**CHABOT-LAS POSITAS COMMUNITY COLLEGE DISTRICT
CHABOT COLLEGE
BUILDING 1200 MUSIC SKILLS CENTER AND SOTA PLAZA**

ADDENDUM NO.	ONE	DATE:	July 14, 2011
CLIENT / PROJECT:	Chabot-Las Positas CCD Building 1200 Music Skills Center and SOTA Plaza	BID OPENING LOCATION:	Chabot-Las Positas Community CD Facilities Planning & Mgmt. Dept. 5020 Franklin Drive Pleasanton, CA 94588
ARCHITECT'S PROJECT NO.	09154.000	BID DATE:	July 20, 2011
ARCHITECT:	BFGC Architects Planners Inc. 150 South First Street, Suite 200 San Jose, CA 95113	BID TIME:	2:00 p.m.
D.S.A. APPLICATION NO.	01-111772		
D.S.A. FILE NO.	1-C2

CONSTRUCTION LAYOUT AREA PLAN

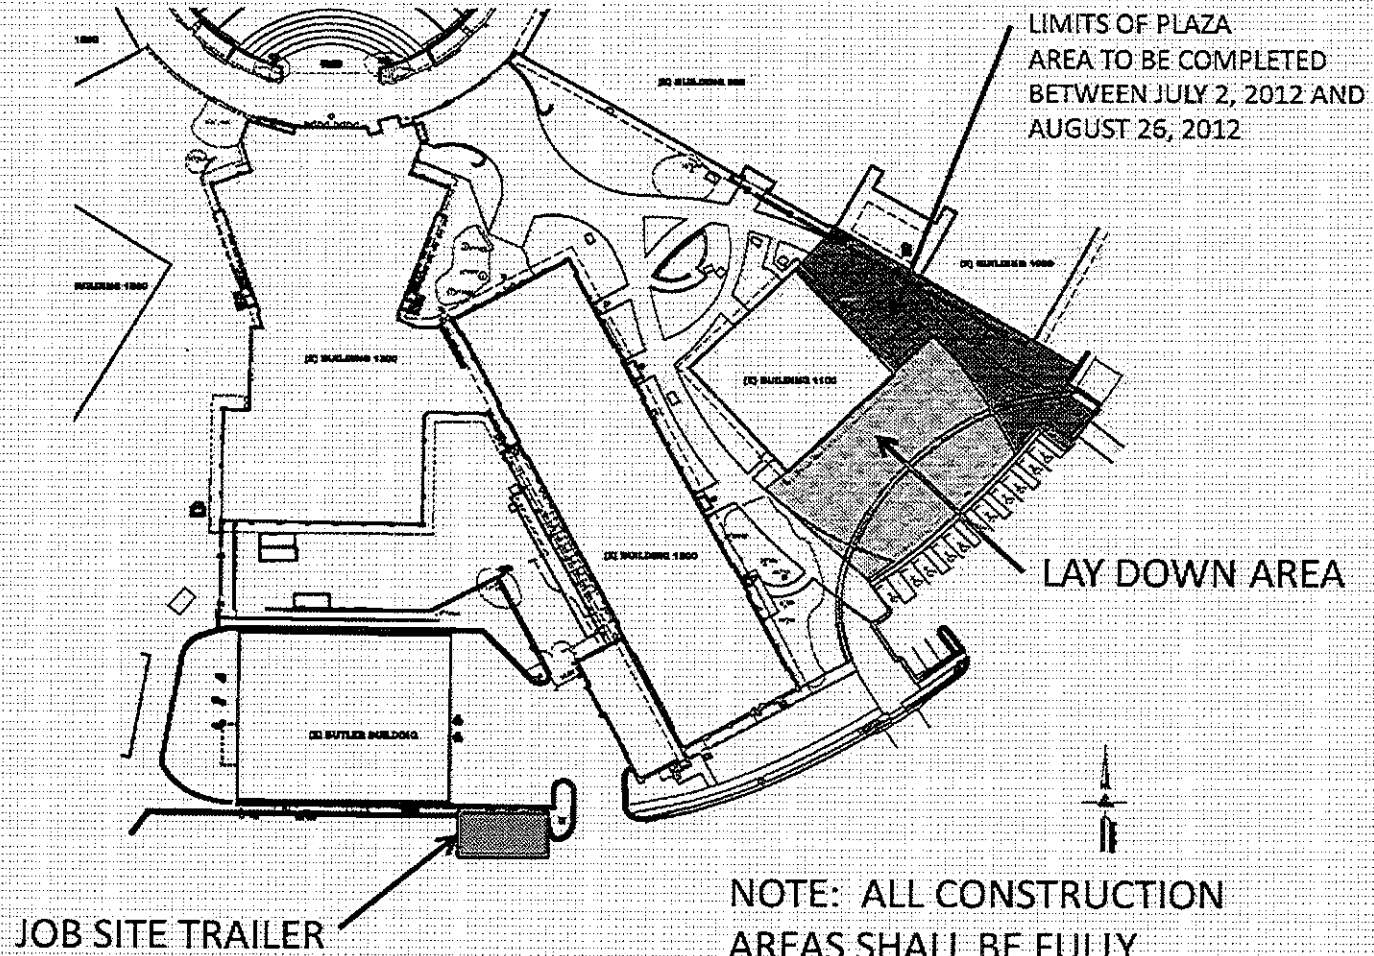
- b. **ADD** paragraph 13.5A to read:
 "The plaza site work between Buildings 1000 and 1100 and extending to the parking lot as well as the walkway and signage in front of the accessible parking on the south side of the site as delineated on attached Construction Layout Area Plan shall be completed during the time frame of July 02, 2012 to August 2012. The accessible parking, associated walkway and signage must remain in service at all other times."

- e. **ADD** paragraph 13.8 to read:
 "13.8 During all segments of work, the Contractor shall coordinate with the Architect, the District's Construction Representative, the Division of State Architect (DSA) District Engineer, to insure all necessary reports, tests, and inspections are submitted for work at the appropriate times."
- f. **ADD** paragraph 13.9:
 "13.9 Construction Layout Area Plan is shown as attached to this addendum."

NOTE: ALL CONSTRUCTION AREAS SHALL BE FULLY ENCLOSED WITH 6'-0" TALL SCREENED CHAIN LINK FENCING
